Errata Sheet V1.0

This Errata Sheet refers to:

**AT91
ARM® Thumb®
Microcontrollers**

**AT91M63200
AT91M43300
Errata Sheet
V1.0**

Figure 1. NWAIT Rising

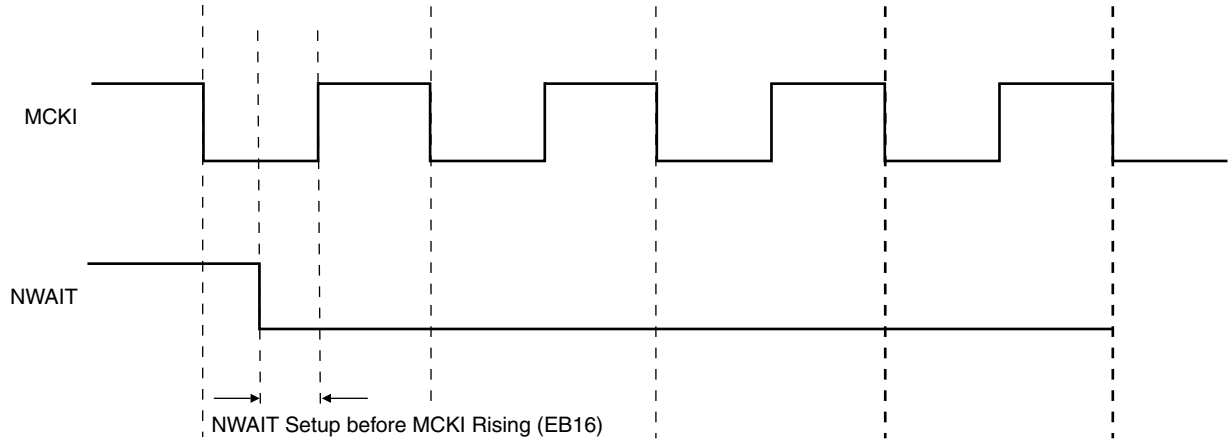
If the NWAIT setup time is satisfied on the first rising edge of MCKI, the behavior is accurate. The EBI operations are not affected when the NWAIT rises.

Figure 2. Number of Standard Wait States is Two

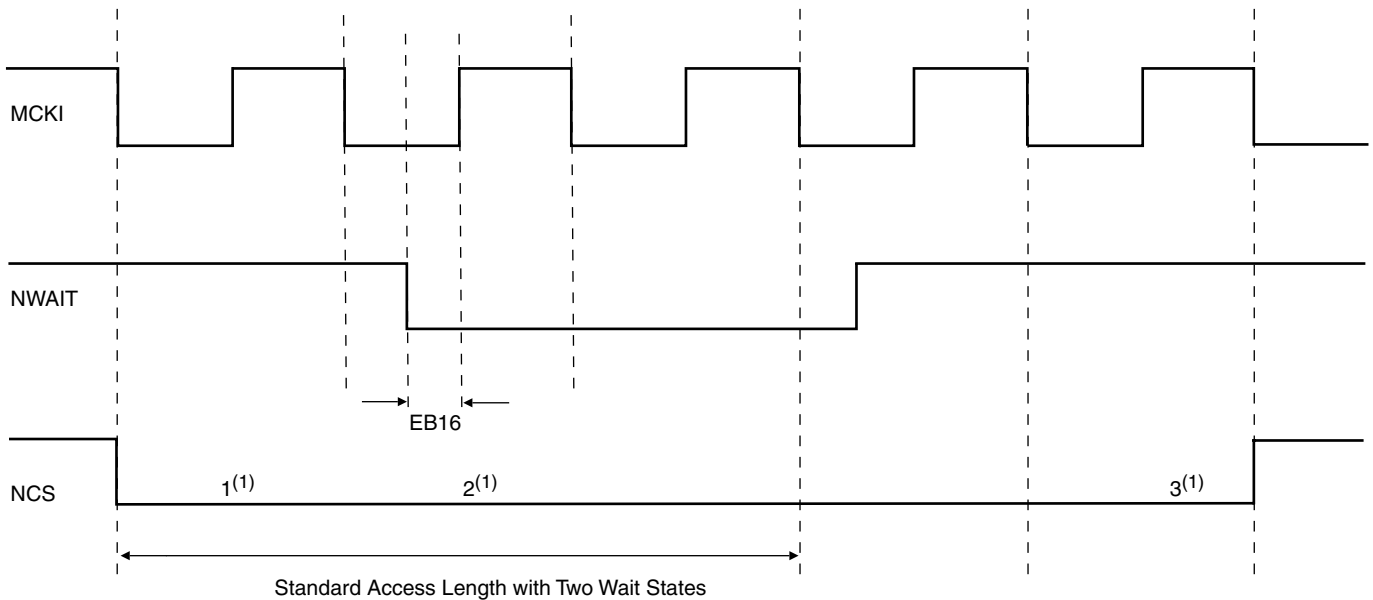
If the NWAIT setup time is satisfied on the following edges of MCKI and if at least one standard wait state remains to be executed, the behavior is accurate. In the following example, the number of standard wait states is two. The NWAIT setup time on the second rising edge of MCKI must be met.

Figure 3. Number of Standard Wait States is One

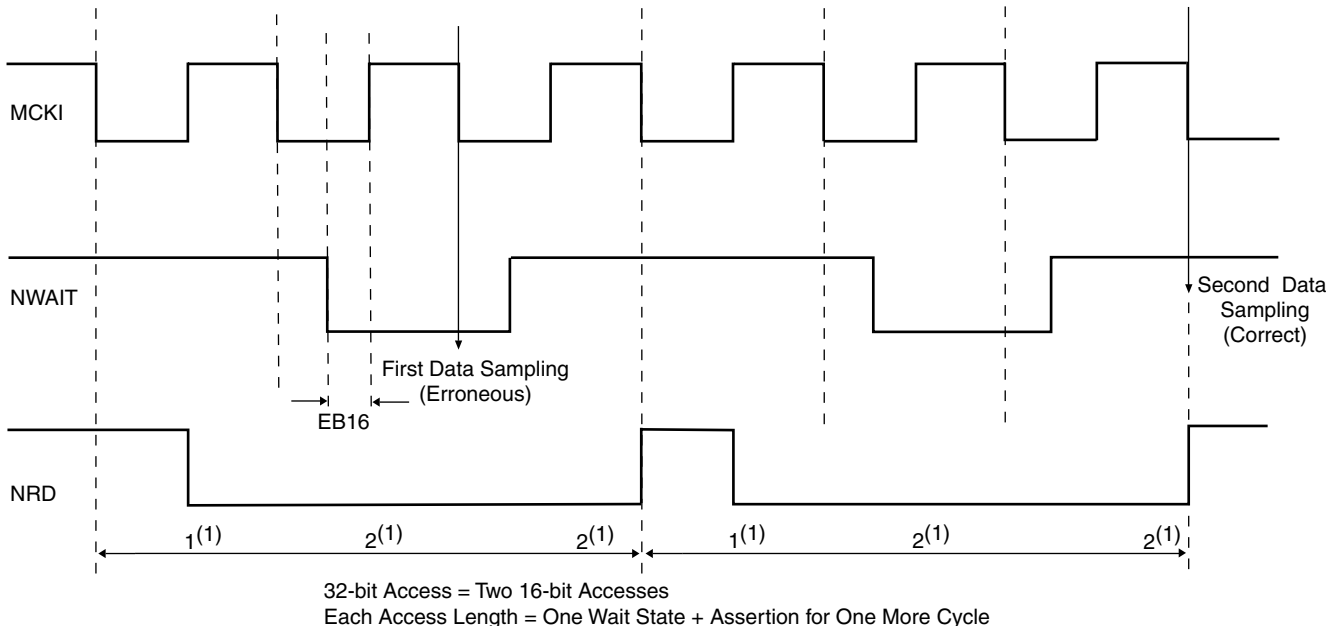
If the first two conditions are not met during a 32-bit read access, the first 16-bit data is read at the end of the standard 16-bit read access. In the following example, the number of standard waits is one. NWAIT assertions do affect both NRD pulse lengths, but first data sampling is not delayed. The second data sampling is correct.

At maximum speed, asserting the NWAIT in the first access cycle is not possible, as the sum of the timings “MCKI Falling to Chip Select” and “NWAIT setup to MCKI rising” are generally higher than one half of a clock period. This leads to using at least one standard wait state. However, this is not sufficient except to perform byte or half-word read accesses. Word and write accesses require at least two standard wait states.

Figure 4. Description of the Number of Standard Wait States

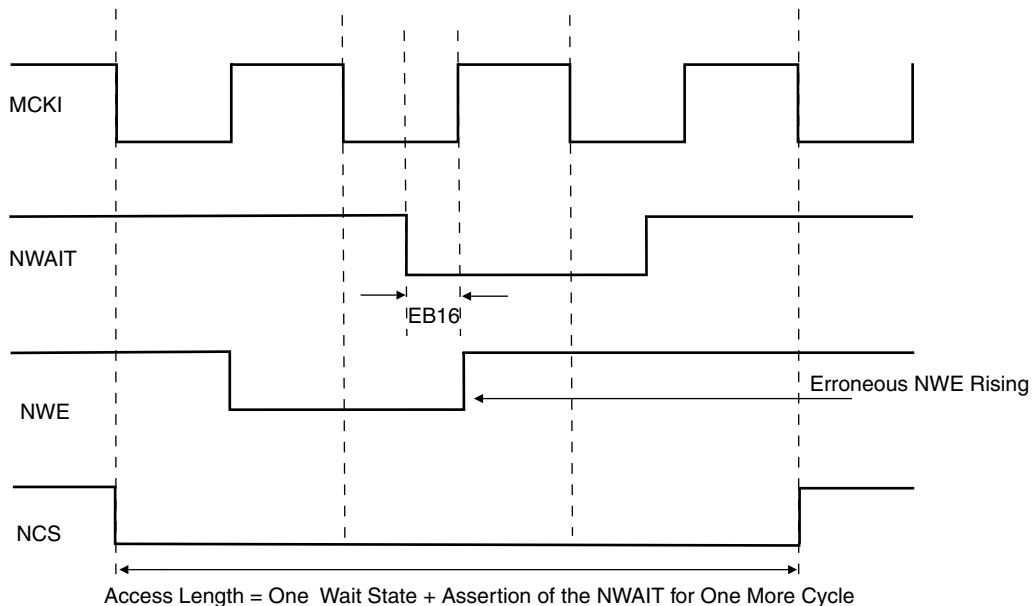
If the first two conditions are not met during write accesses, the NWE signal is not affected by the NWAIT assertion. The following example illustrates the number of standard wait states. NWAIT is not asserted during the first cycle, but is asserted at the second and last cycle of the standard access. The access is correctly delayed as the NCS line rises accordingly to the NWAIT assertion. However, the NWE signal waveform is unchanged, and rises too early.
